## MEMORANDUM

**SUBJECT:** Set down Report - ZC #14-18A (Brookland Manor, Block 7)  
First Stage PUD Modification and Second Stage PUD

Approved Block 7 Site Plan

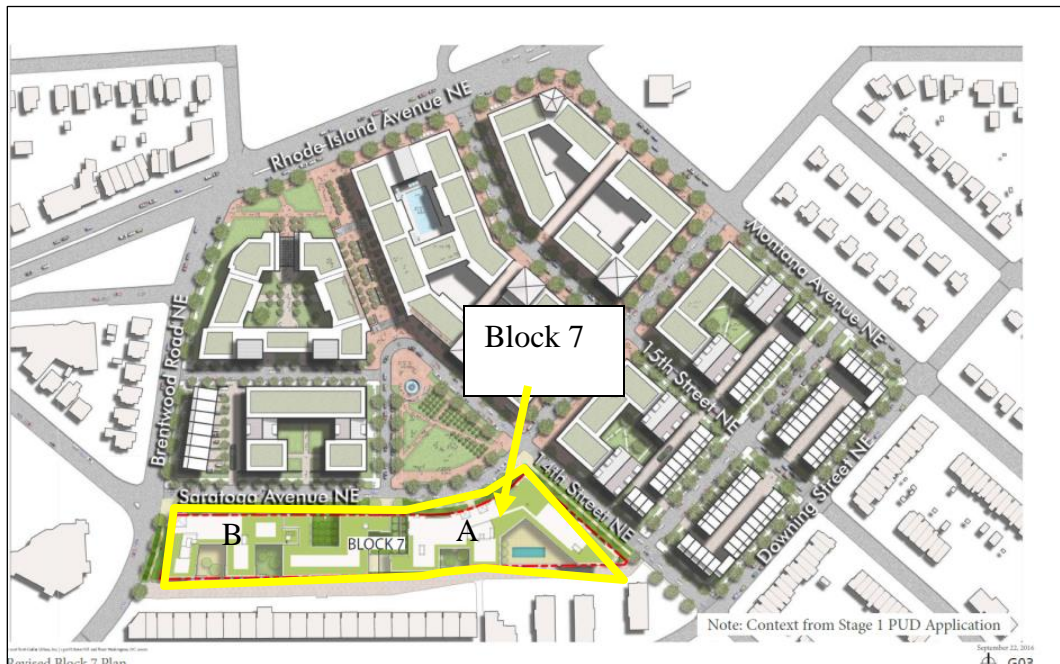
The applicant requests an amendment to the approved plan to replace the two-over-two row buildings with an apartment building. The Block would now be developed with two apartment buildings with the senior building relocated to the western portion of the block while the second apartment building would be on the eastern portion of the block as shown on the Site Plan below. The senior building, Building A, would have 200 units and Building B would have 131 units.
